Re: 14th & Ursula Mixed-Use (DA-1279-53 / 2022-4021-00) / 1st Review Comment Response

Thank you for taking the time to review our initial submission for the 14th & Ursula Mixed-Use at Fitzsimons Village along with City staff and providing valuable feedback, which was received on July 15, 2022. Comment responses have been addressed on the following pages.

PLANNING DEPARTMENT COMMENTS

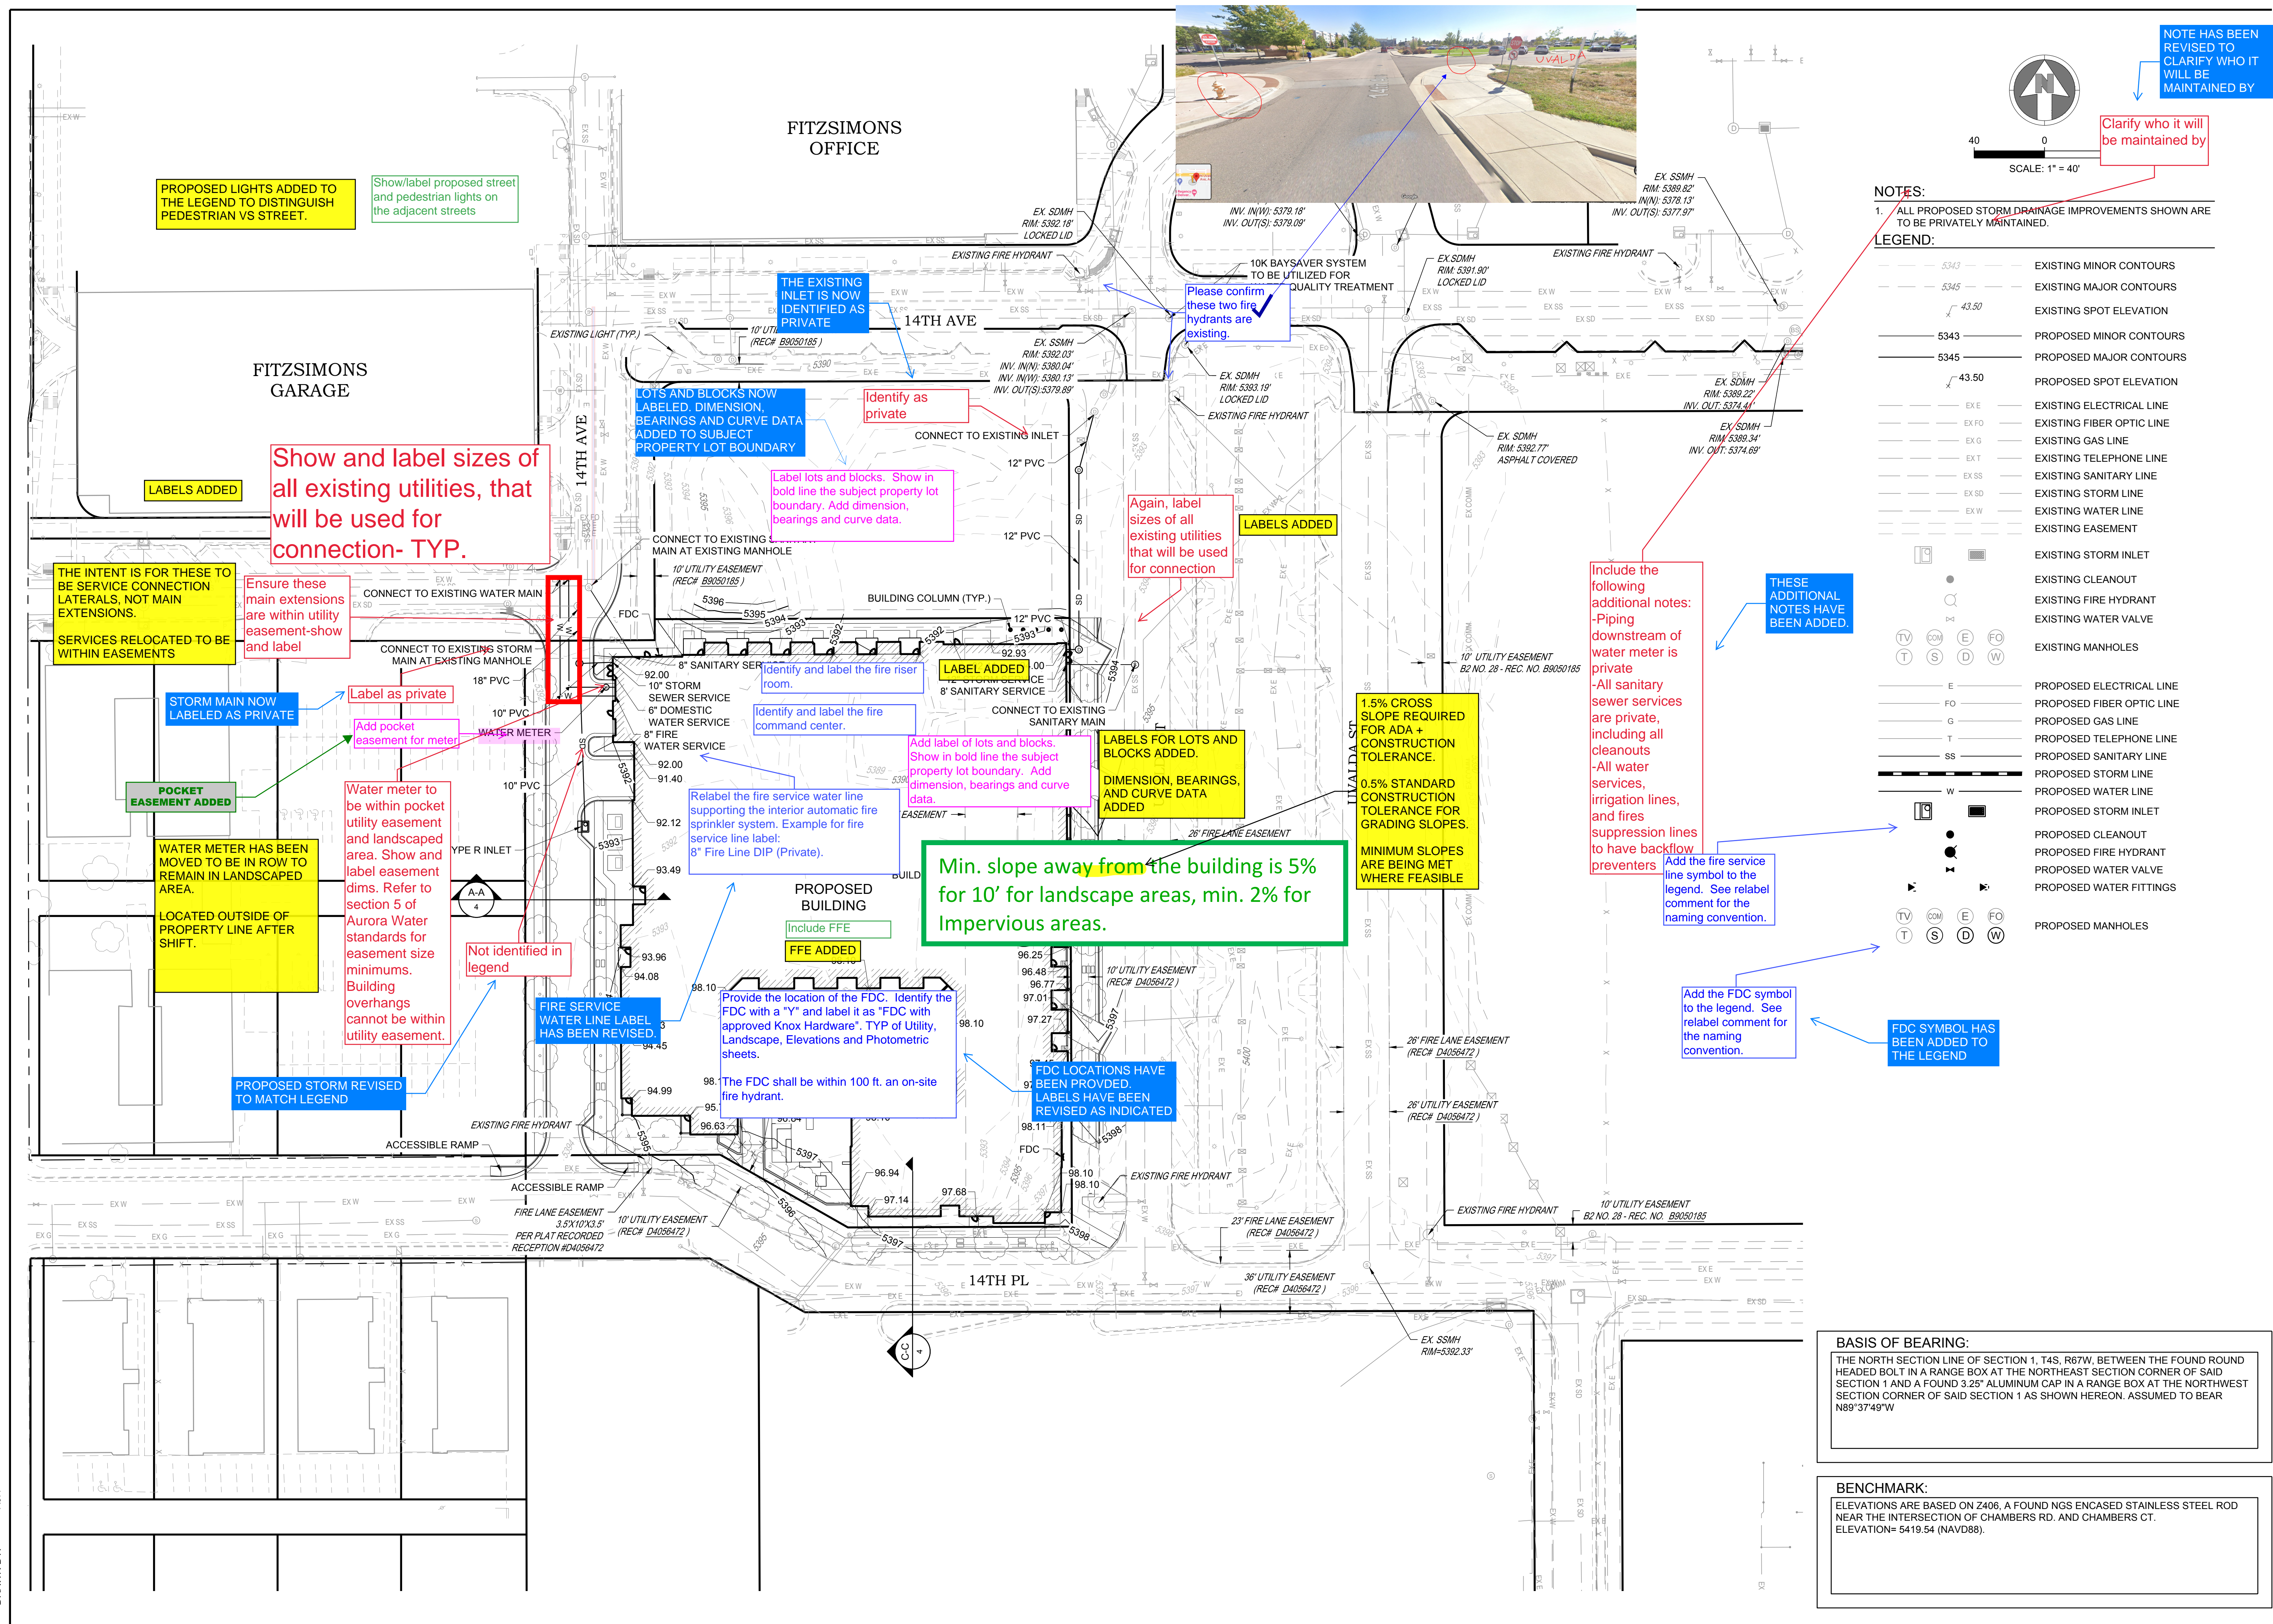
The 2015 IFC, Section D105.1 requires Aerial Fire Apparatus Access Roads where the vertical distance between the grade plane and the highest roof surface exceeds 30 feet (9144 mm). Additionally, aerial fire apparatus roads shall have an unobstructed width of 26' and be located within a minimum of 15' and a maximum of 30' from the building, positioned parallel to one entire side of the building. The roadways near the mentioned areas do not appear to meet the fire aerial apparatus road code or the COA emergency midblock setup requirements. Therefore, along with the turn template, show how this site will provide the an aerial fire apparatus road that meets the intent of the code.

Per 05/25/2022 with Mike Dean, the proposed location of curb in excess of 30' from the building is acceptable. The constraints of the Fitzsimons masterplan, applicable street cross section, dimensions and easements do not allow for a 30' access width to be obtained along Uvalde.

SHEET TITLE:
STREET
SECTIONS

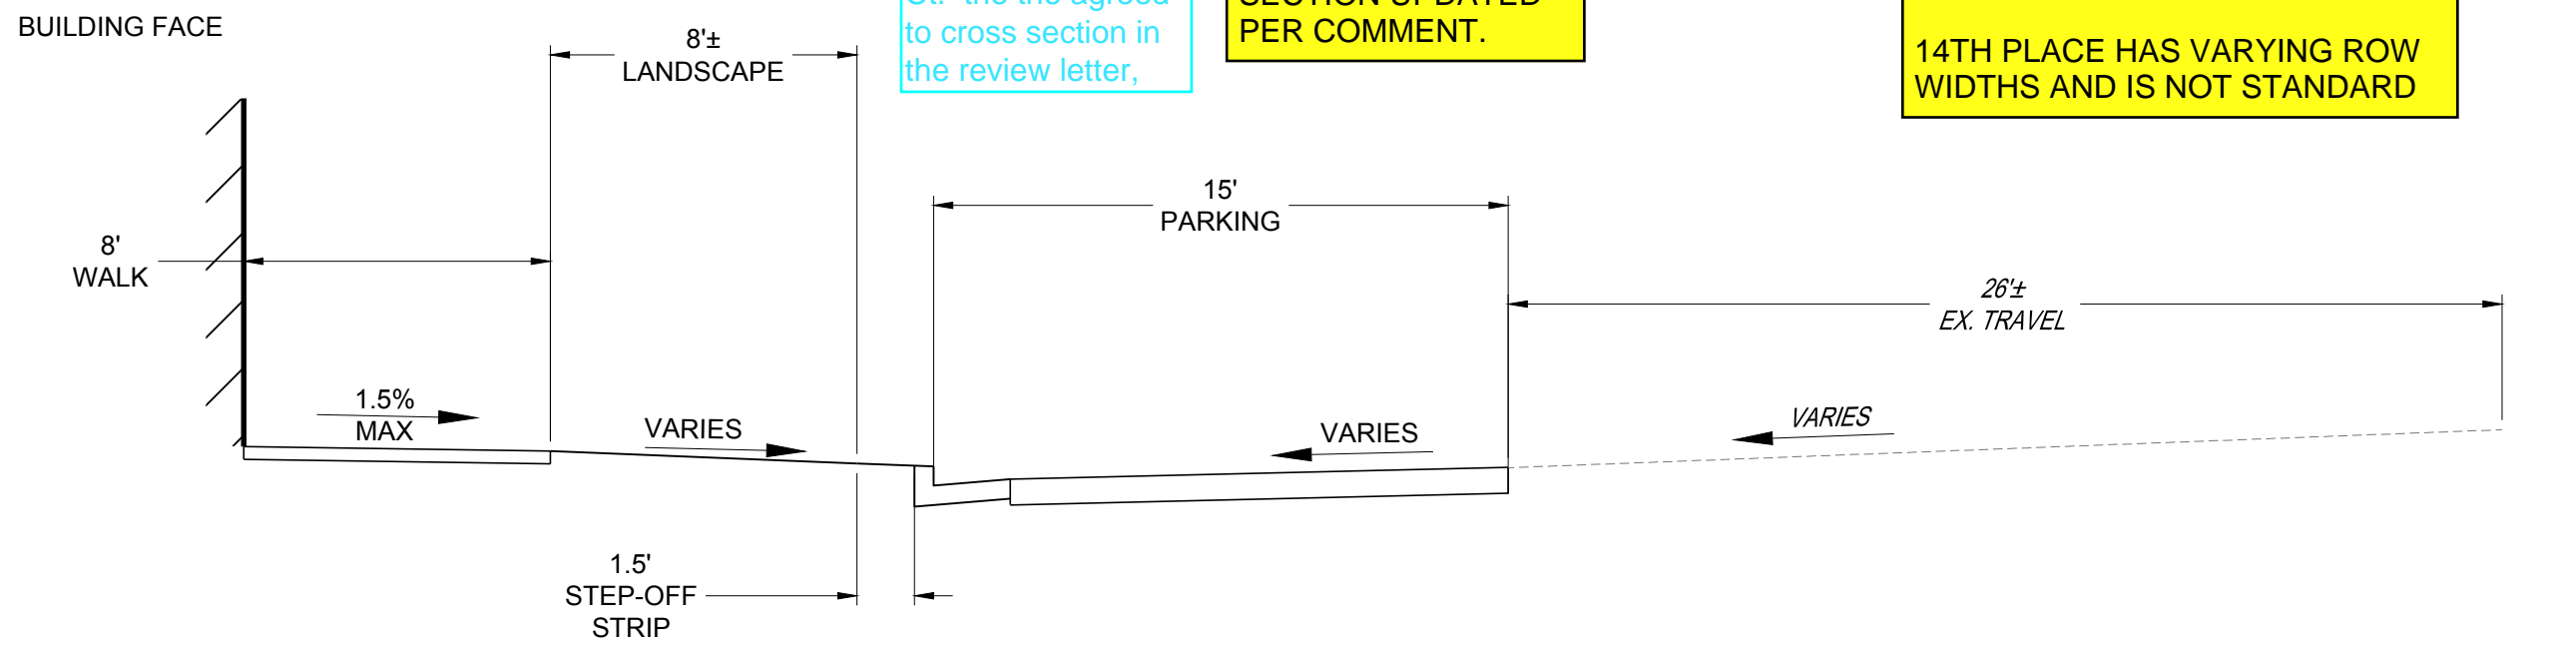
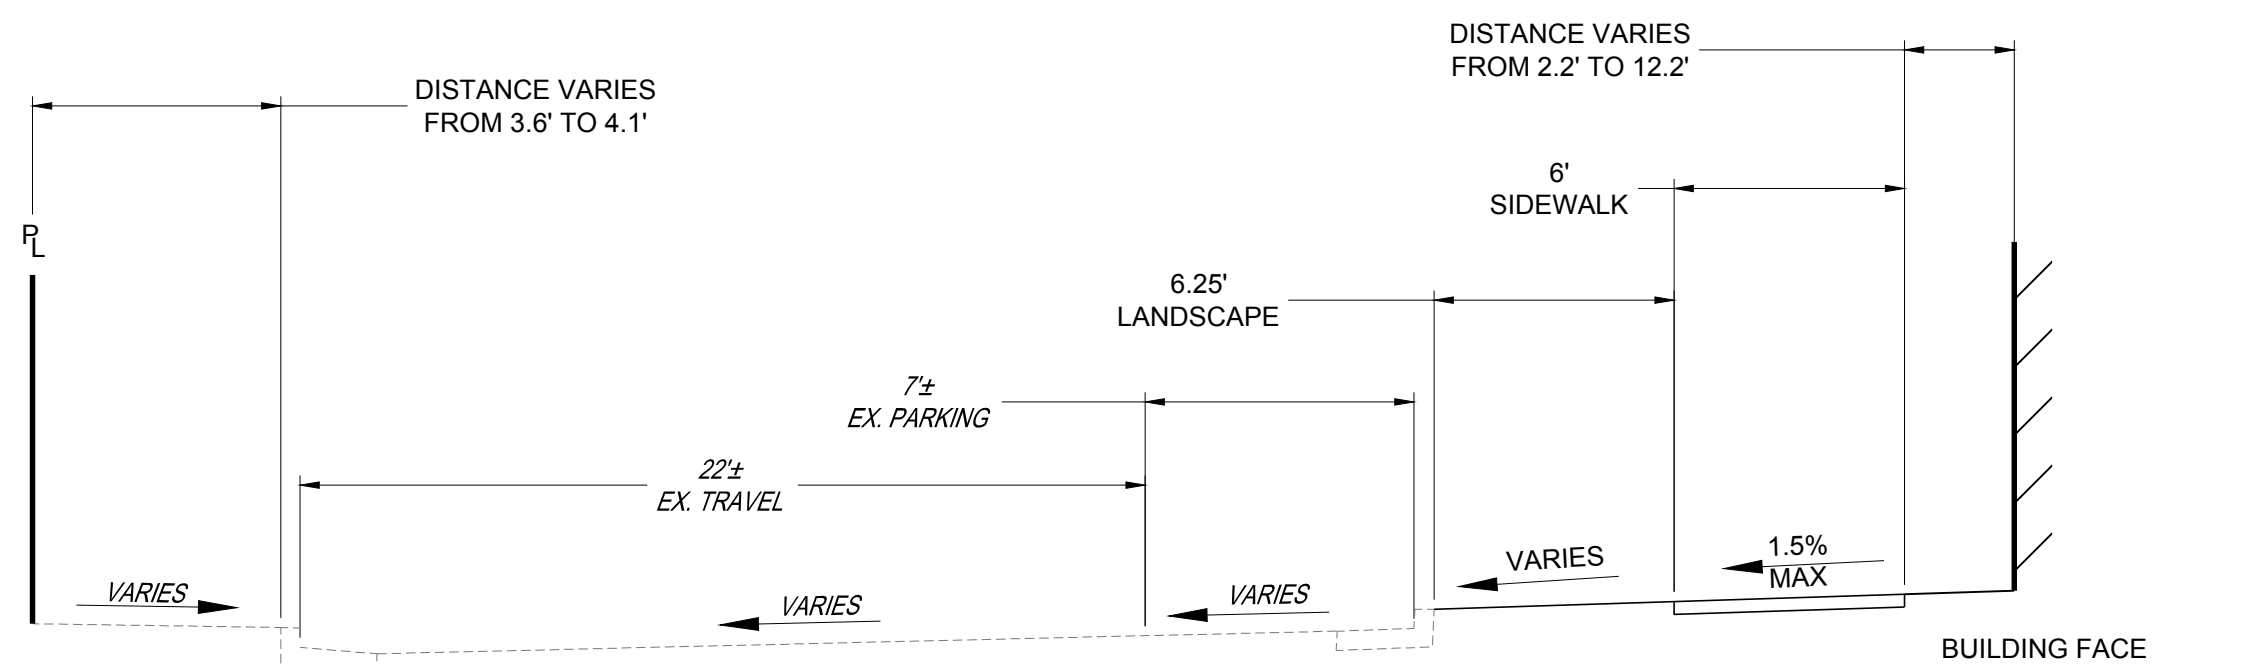
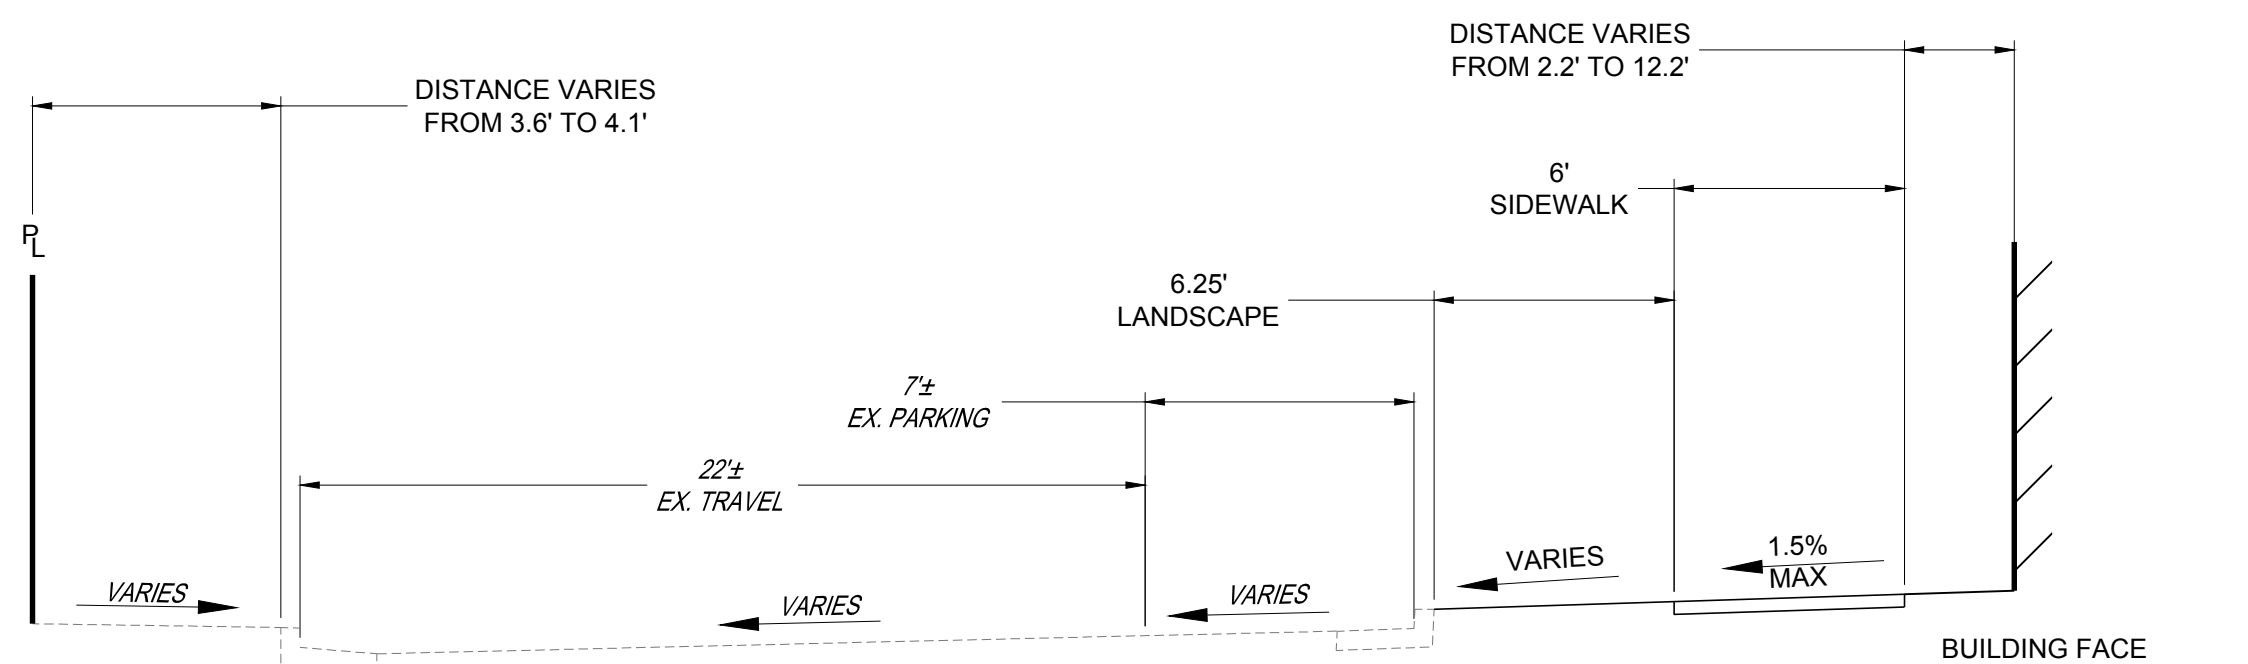
This appears to be problematic for maneuvering large vehicles through this area. Please ensure a complete turn template is provided.

NO PARKING - FIRE LANE SIGNS ARE ON THIS STREET, NEEDS TO BE ENFORCED

"SIGNAGE AND STRIPING" package shall be included for approval with the Site and Civil Plan, the sign package shall include fire lane and handicapped parking signs, sign details, handicapped parking stall details, and locations for all. Sign package shall include all signs as required by other City of Aurora departments. see example below.

"SIGNAGE AND STRIPING" package shall include the following:
-Handicap accessible parking signs, include post.
-Handicap accessible curb ramp detail.
-Plan view of detectable warning and well.
-Side cross section views of detectable warning, well, curb and gutter.
-Front section views of detectable warning, well, curb and gutter.
-Dome and detectable warning details. Note: The top diameter of the truncated domes shall be 50% to 65% of the base diameter.
-Handicap accessible parking layout. Provide a symbol and label for the location of the handicap accessible sign with this layout. Ensure the sign is back far enough not to be within the curb "roll-over" area.

Encroachment in the fire lane is strictly prohibited. A discussion may need to occur to ensure adequate fire lane/no parking signs are provided and posted.

THE REQUIRED ELEMENTS WILL BE INCLUDED IN THE CIVIL PLAN SUBMITTAL.

EXISTING SIGNS ARE ALREADY IN PLACE APPEAR ADEQUATE, JUST NEED TO BE ENFORCED
